Analysis of EU policy proposals for DG ENER Lot 12 Commercial Refrigeration

Including comparison with policy thresholds and product data from other regions

21 August 2014

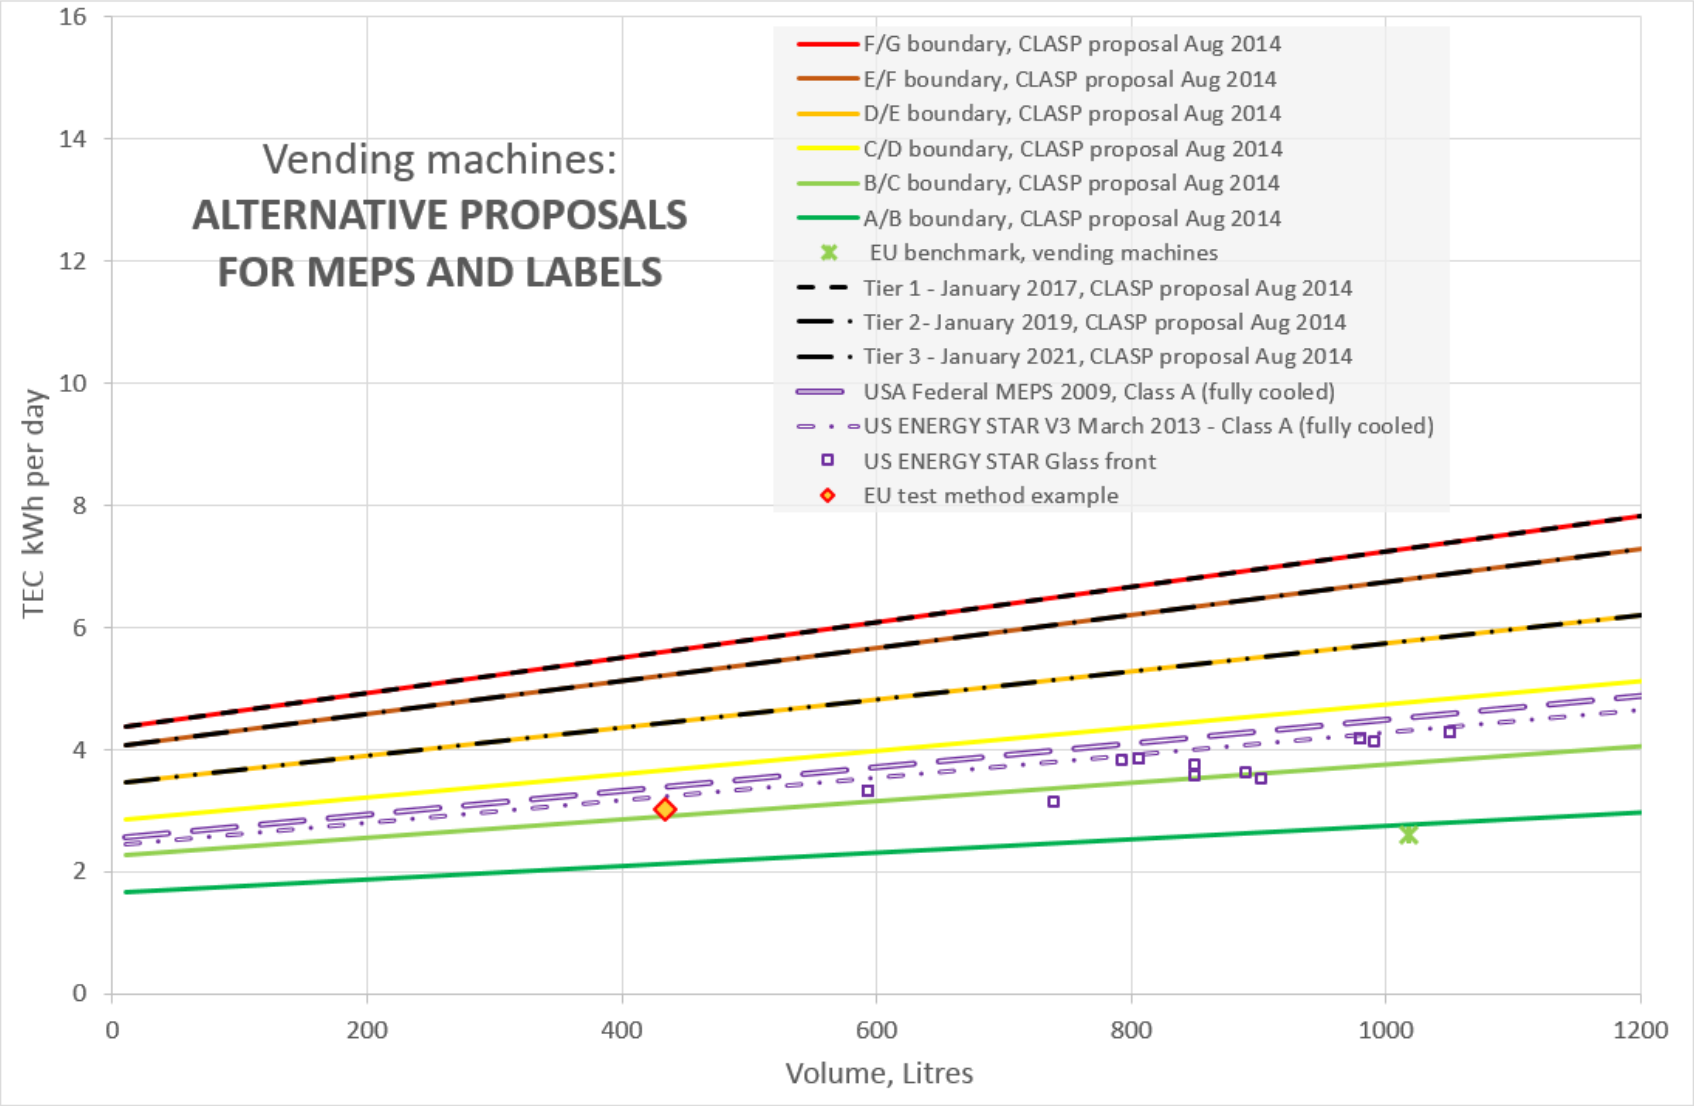
An alternative proposal of MEPS and EEI reference line were developed and are presented in Table S3 and Figure S6. This alternative proposal ensures the energy label better covers the current range of market performance (leaving legacy products in label class G). It also allows for the differentiation of the best performing models and scope for future improvements. And the MEPS align with the energy label classes to minimise confusion in the market and facilitate market surveillance. Whilst the minimum requirements are closer to the US MEPS than those in the Commission's draft working document, they are not as stringent as the US. The reason for this is to allow a period of grace for the new EU test method to become established; and then a suggested regulatory review by 2017 of the level of ambition for Tiers 2 and 3.

Figure 2. Comparison of proposed EU MEPS, with UK, USA and Australian policy thresholds for vertical remote open display cabinets, all normalised to EN 23953:2005.

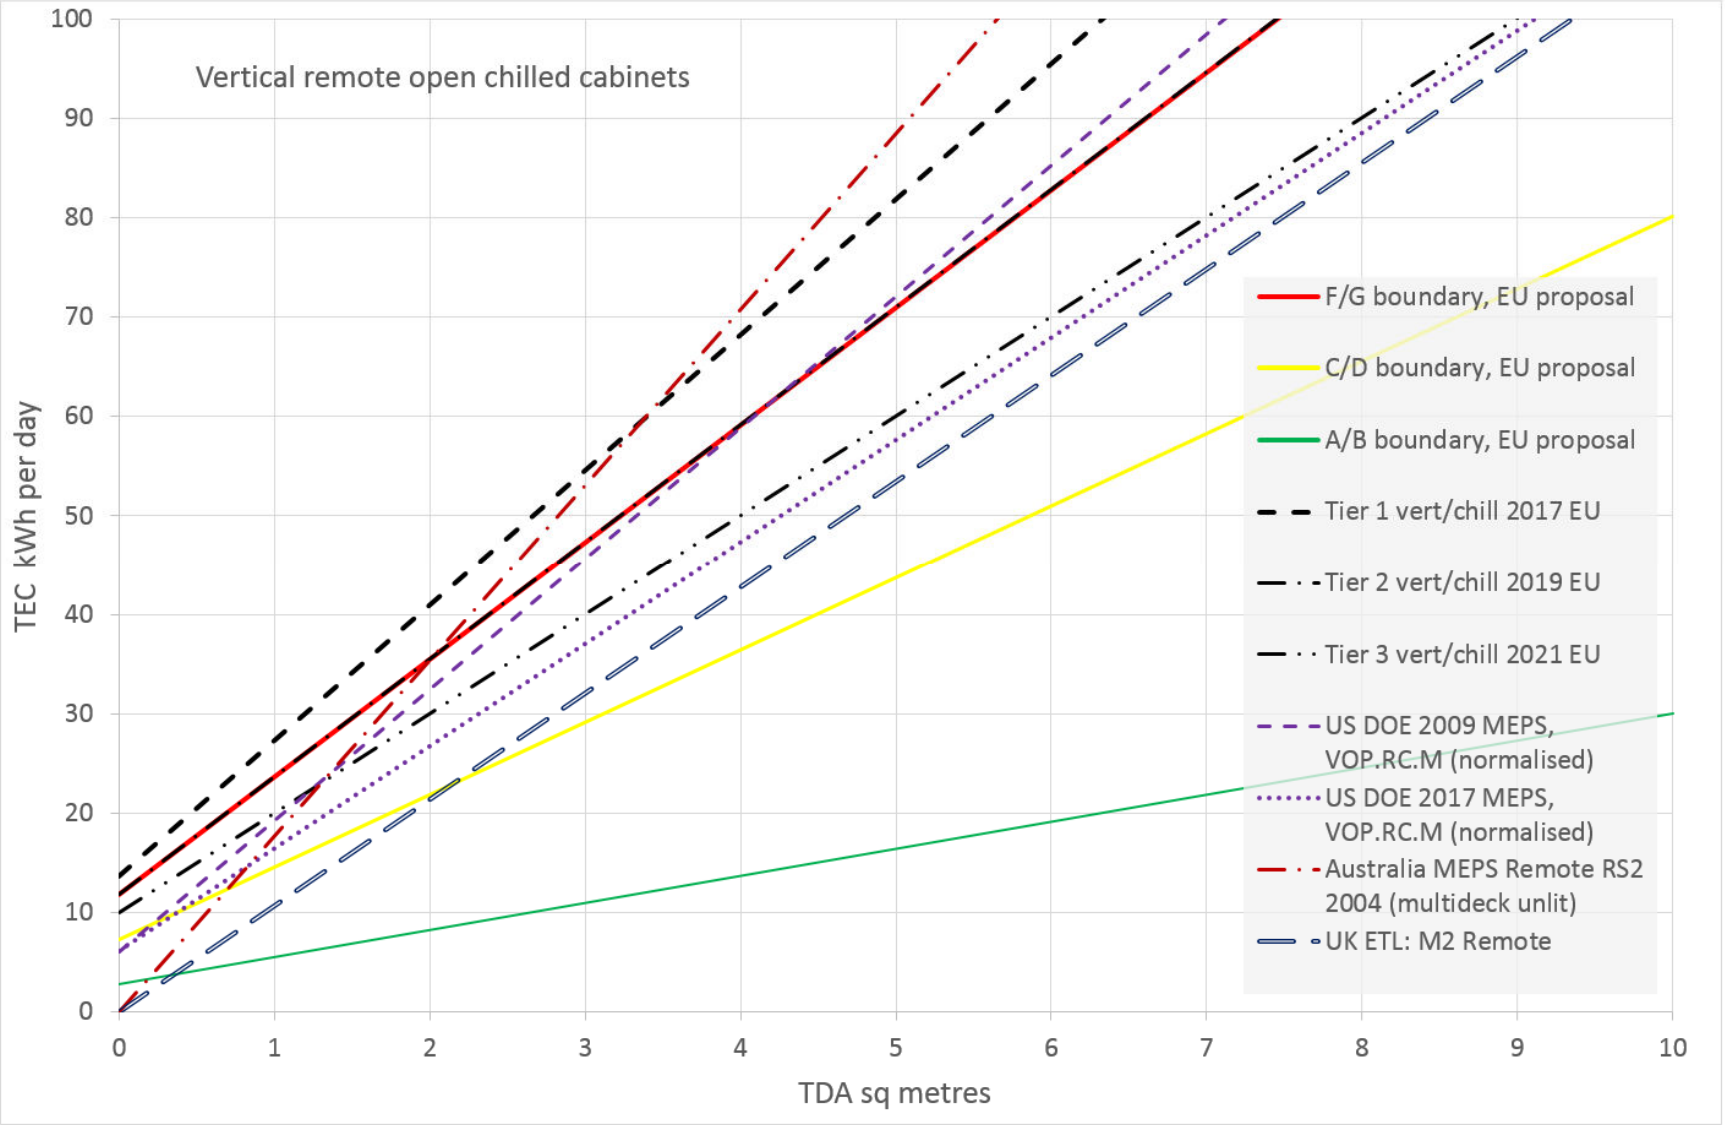
If the proposed draft working document is adopted without modification, comparing the EU proposals with MEPS from other economies that regulate these same products in Figure 2 indicates there may be scope to increase the ambition of the EU proposals. Some observations on these data are:

Figure 3. Comparison of proposed EU MEPS and label boundaries with normalised data from Eurovent certification data for 2014, California (CEC), Australia and the UK Energy Technology List, showing vertical, remote open cabinets of temperature M2 (chilled).

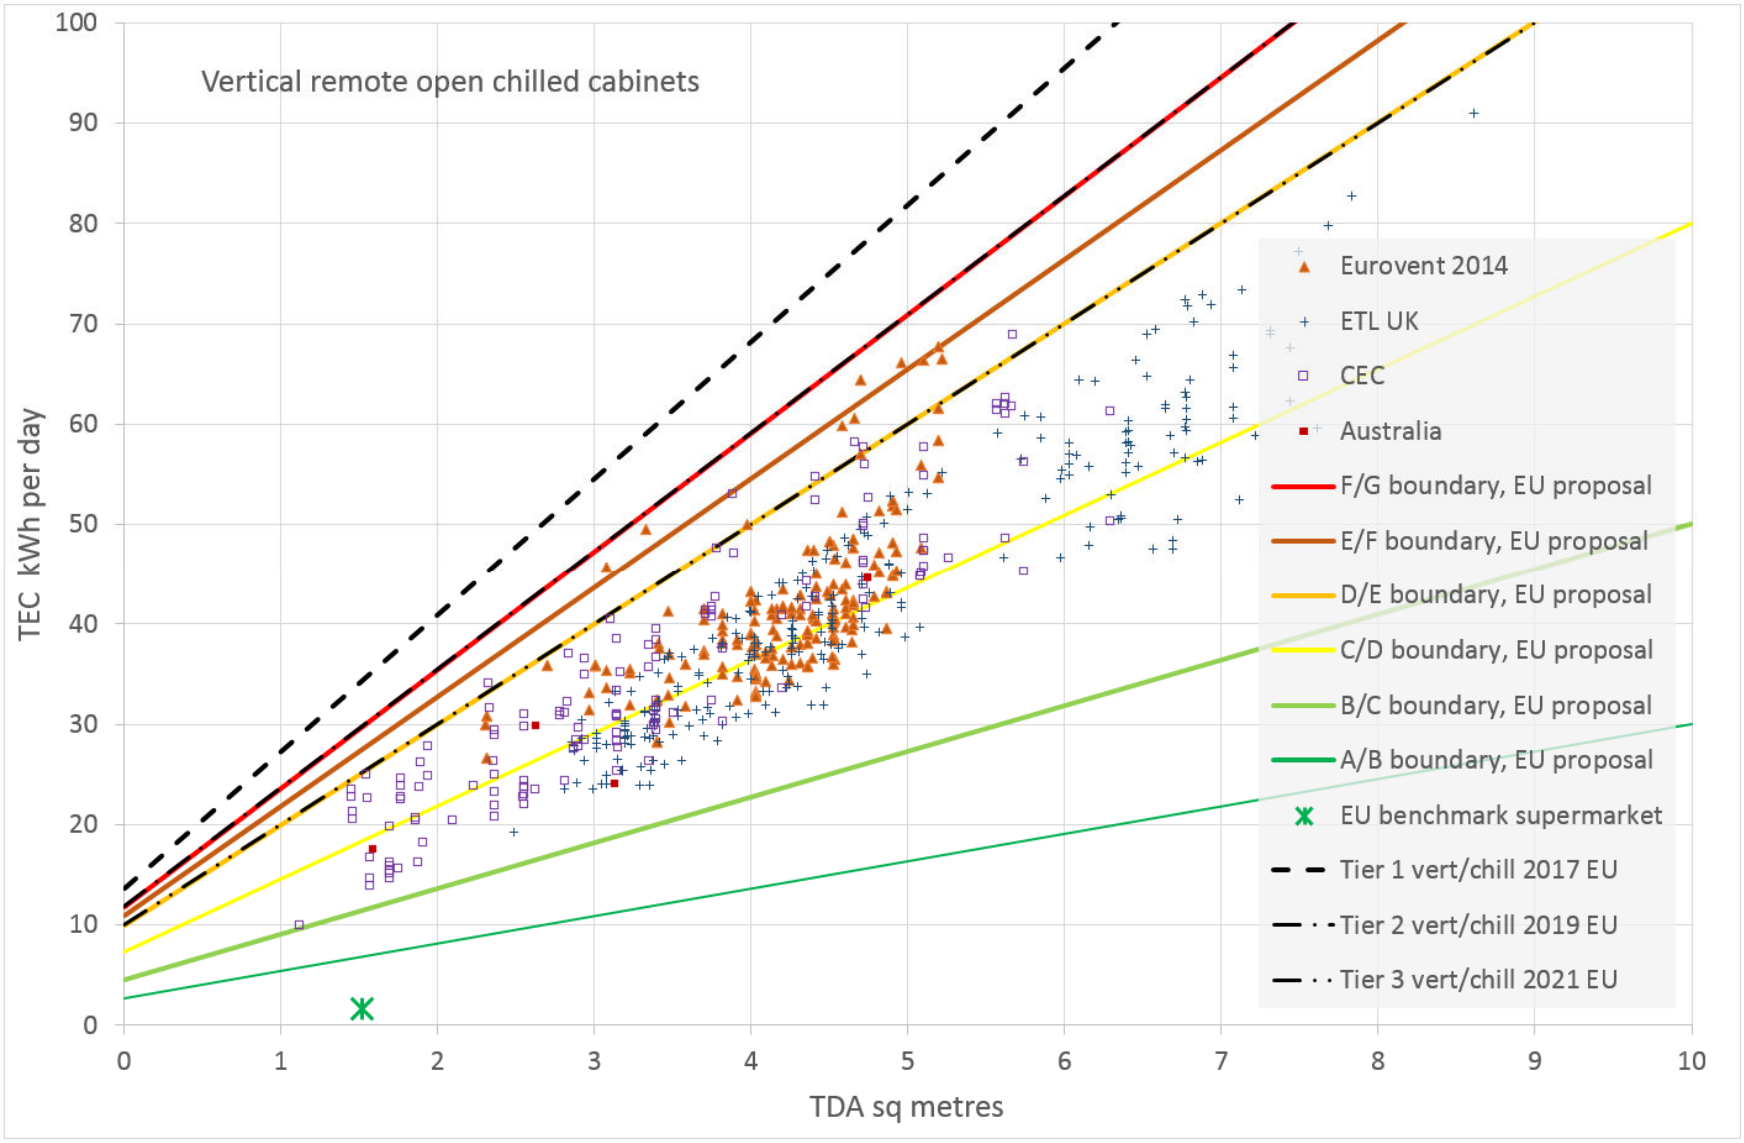
3. The EU MEPS appear to remove from the market very few of the open cabinets included in these data sets. Some poor efficiency open cabinets that do not appear in these data sets will be removed from the market, but most of these open cabinets from 2013 will remain on the market beyond 2021 under the current DG ENER proposals. This would imply that the proposed MEPS would allow a significant portion of the open cabinet market to remain, unaffected by the regulation.

Figure 4. Comparison of proposed EU MEPS and label boundaries with normalised data from Eurovent certification data for 2014, California (CEC), Australia and the UK Energy Technology List, showing vertical, closed, remote cabinets of temperature M2 (chilled).

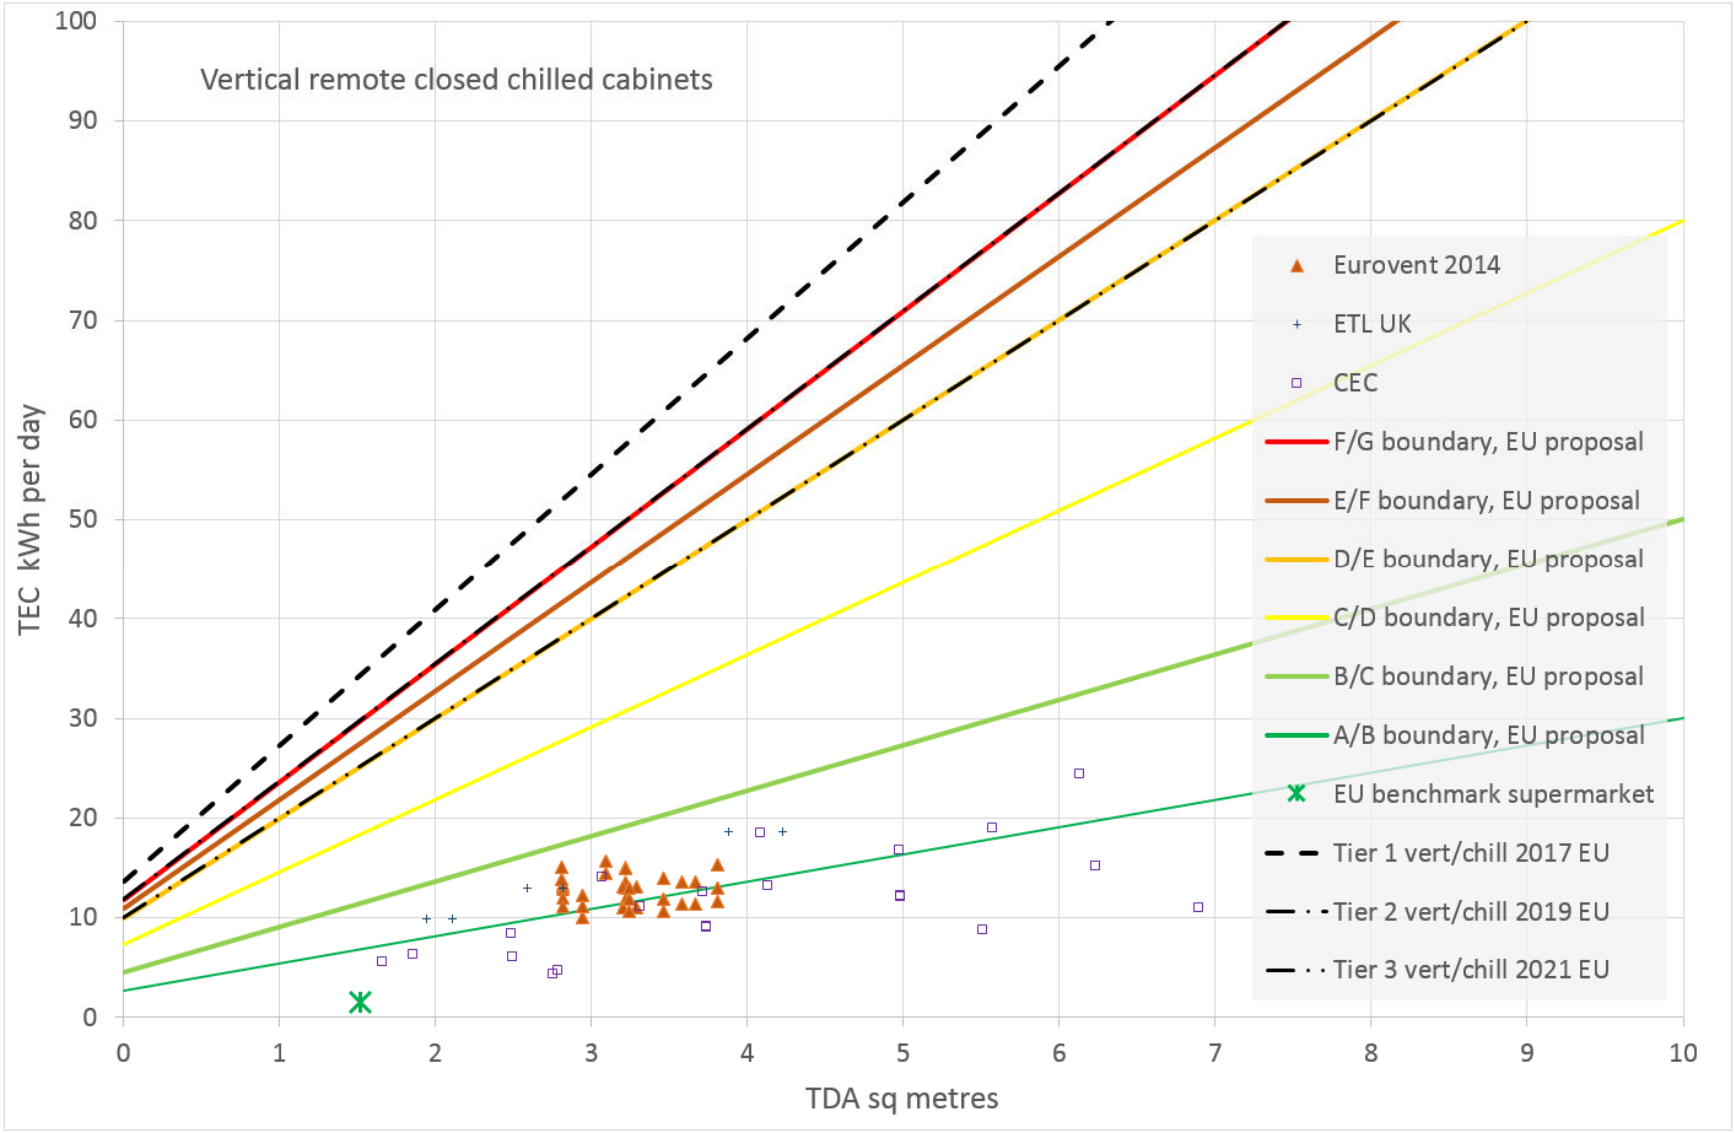
The range of performance of open cabinets contrasts sharply with Figure 4 which includes only remote closed cabinets:

1. This shows how closed cabinets can consume less than one third of the energy of open cabinets for the same TDA.
2. All of these closed cabinets (which are only better performing cabinets on the markets due to data sources used) already achieve EU A or B energy class, including a few close to the proposed EU benchmark level.

Figure 6. EU proposals alongside requirements from the UK, USA and Australia - all non-EU lines refer to remote, frozen, horizontal open cabinets and are normalized to an L1 reference temperature.

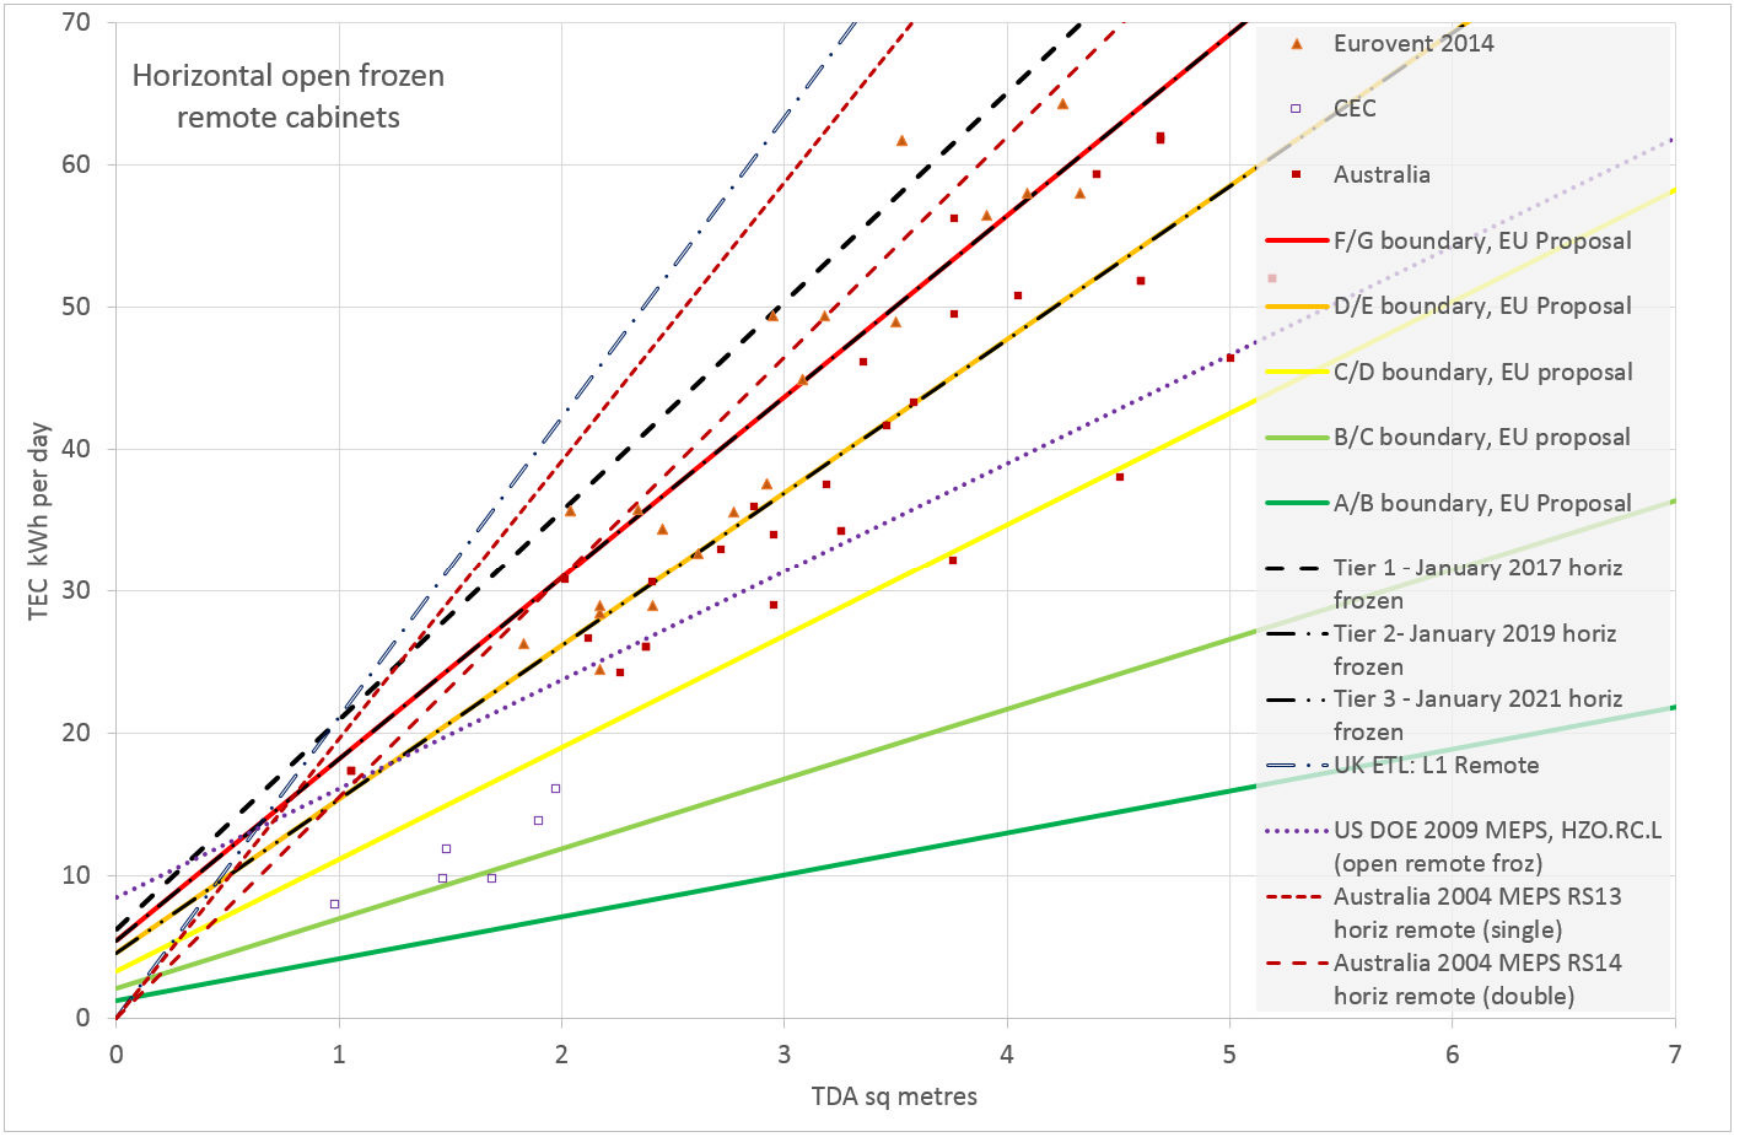
2. If more of the open remote cabinets were converted to closed type, energy savings would result, but it can be seen from Figure 6 that most of these open remote cabinets can remain on the market even after 2019, although the 2021 MEPS would remove the majority of them. None of these models will be affected by the 2017 MEPS. Worse performing open cabinets (not included in these data sets) would be forced off the market, but many open frozen cabinets could still be present in shops.

3. The US MEPS of 2009 for open frozen horizontal remote cabinets are more stringent than the 2021 requirements for the EU (Figure 6).
4. The Australians set MEPS separately for open and for closed cabinets (and also separately for integral and remote), and therefore the MEPS for closed cabinets are much more stringent (as shown in Figure 7, when compared with Figure 6).
